## **New Crankcase Heater Design for 06D/E/CC Compressors**

Shown below in Figures 1 and 2 are photos of the new and old designs.

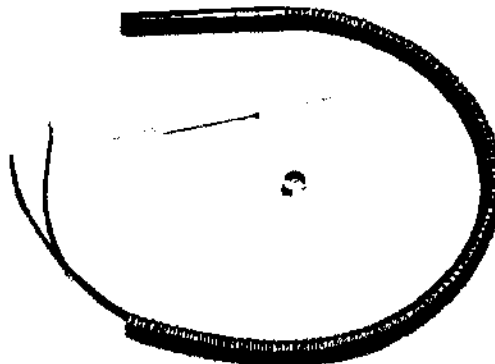
interchangeable with the old design, there are several dimensional differences. One is the shape of the heater (straight vs. L shaped) and the other is the wire length. The new shorter wire length is still adequate to reach the 06D/E terminal box. If the heater is connected to some other location which is further away, it will require splicing. The new designs are also produced by new suppliers and have different UL and CSA approval numbers. Contact Carlyle Application Engineering if this information is required. We will automatically convert to the new design as we use up our current inventory.
